Subject: New adjustment of the fuel contents indication of the ILEC engine control unit.

Serial Number Applicability: All ASH 26 E serial numbers.

Fig. 1:

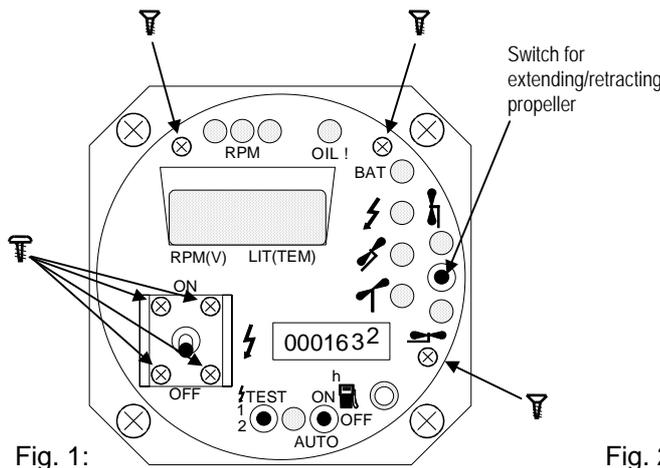
- Undo the seven screws marked in Fig. 1 and remove the front face.
- The aircraft must be sitting on its tail on a level ground and the fuselage tank must be filled until fuel flows over into the capacity reservoir behind the baggage compartment. Wait until the fuel level is equal in both fuselage tank halves; where necessary repeat the procedure until fuel again is overflowing into the capacity reservoir.
- By means of a small Phillips screwdriver the fuel contents indication is to be changed (at the potentiometer marked in Fig. 2) so that the indication just changes from 15 to 16 liters.
- Refit front face and switch cover plate.
